# Notice of Modification

**Development Approval:** MP 10\_0012 granted by the Planning Assessment Commission on 16 March 2012

**For the following:** Woodlawn Waste Expansion Project

**Modification:** MP 10\_0012 MOD 1: Modification for changing the site water and leachate management to allow the use of:

**Appendix 5 – Revised Water and Leachate Management Plan prepared by Veolia Environmental Services (Australia) Pty Ltd**

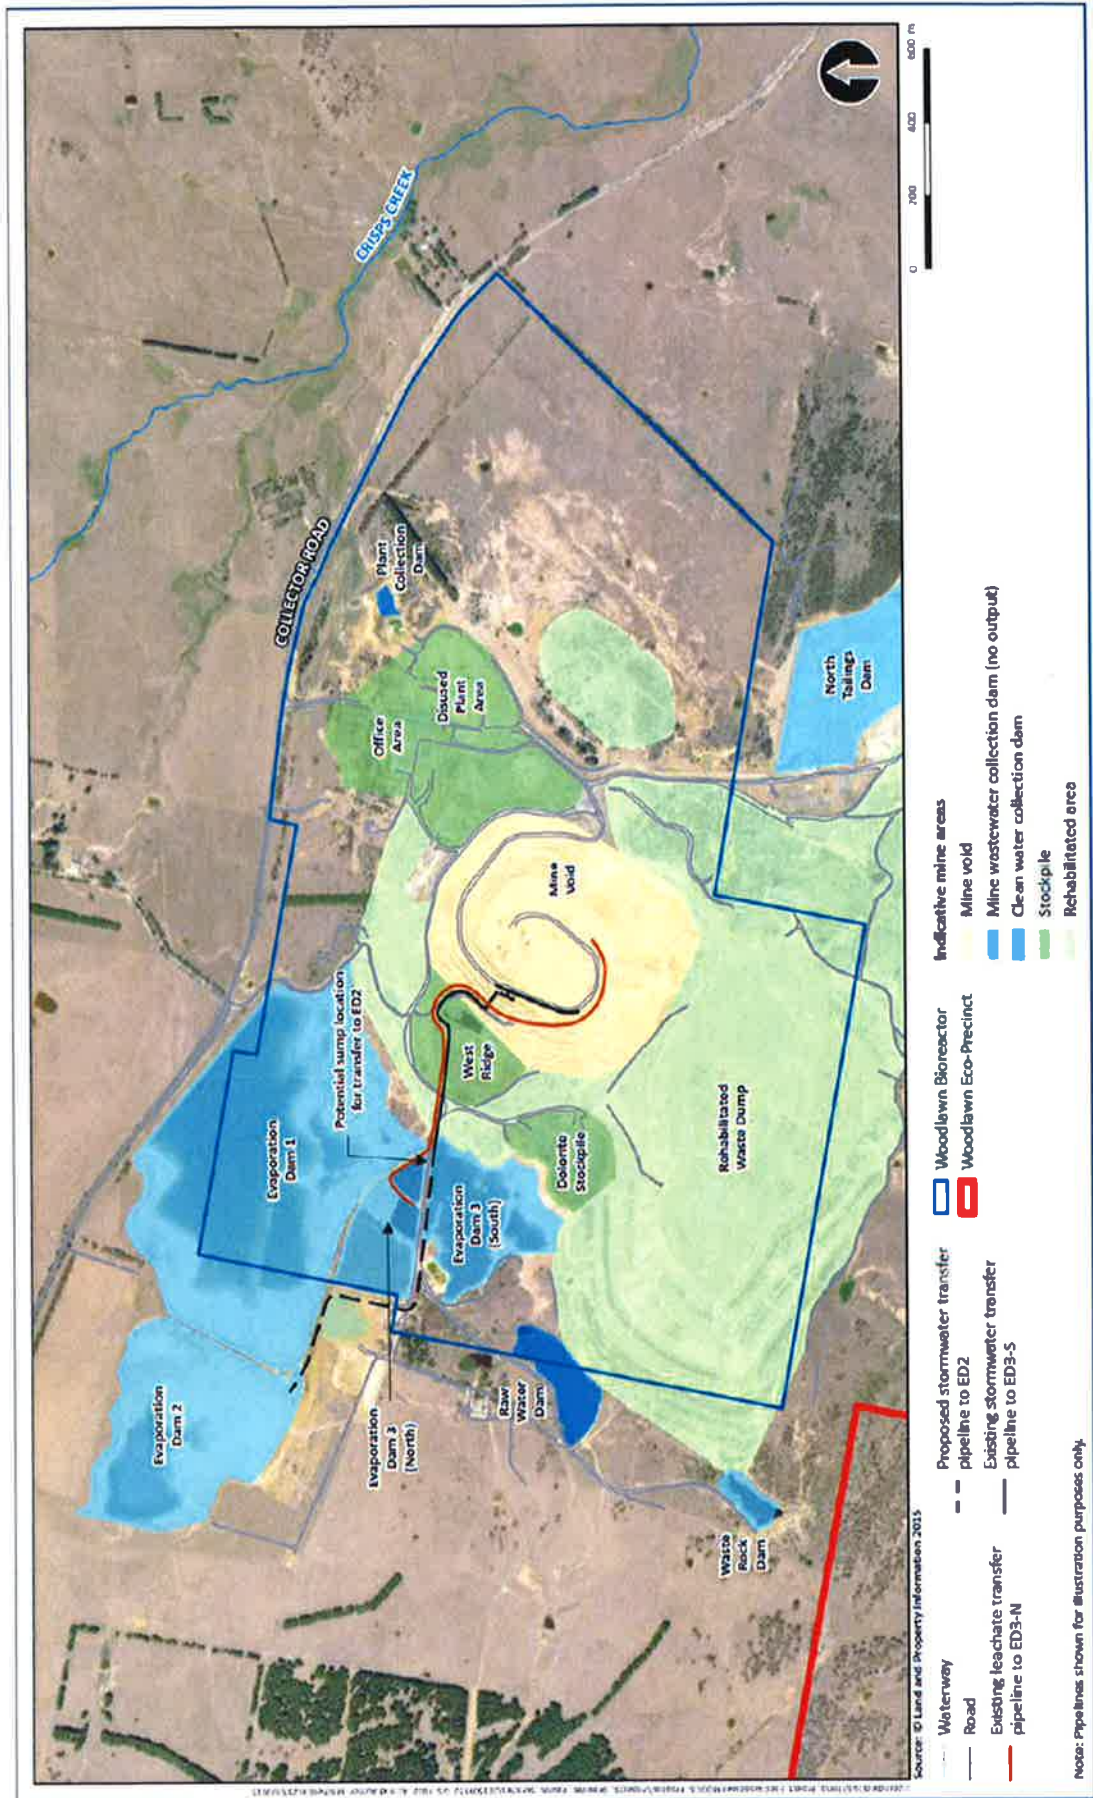
- f) **a copy of the minutes of the Community Liaison Committee Meetings;** and
  - g) any other matter required by the Director-General.
- (n) Schedule 7 - Appendix 5 is included by the insertion of the following new figure titled Revised water and leachate management plan as shown in **bold and underlined** as follows:

**Appendix 6 – Detail of ED3S, showing ED3S-S prepared by Veolia Environmental Services (Australia) Pty Ltd – Revision F dated 21 July 2016**

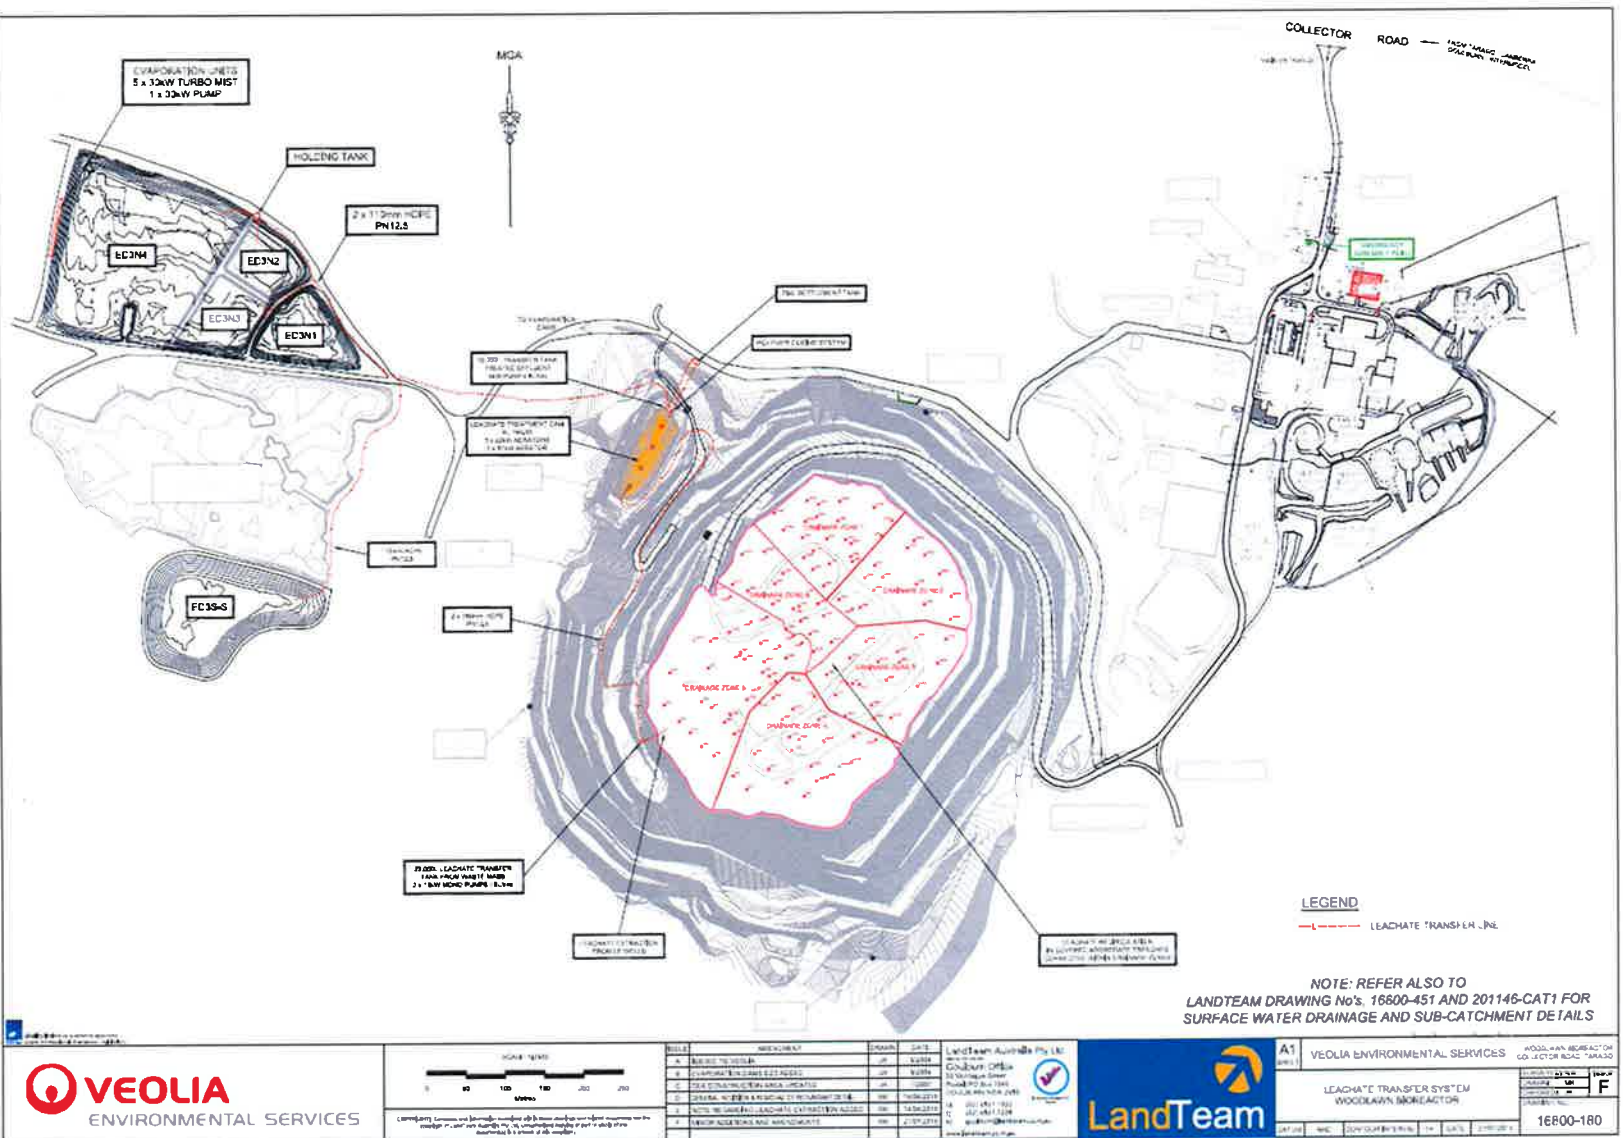
- (o) Schedule 7 - Appendix 6 is included by the insertion of the following new figure detailing ED3S and ED3S-S as sown in the **bold and underlined** as follows:

18C. Treated leachate must not be discharged to any part of ED3S, other than ED3S-S, until such time as the Long Term Leachate Management Strategy has been approved by the Secretary and the EPA.
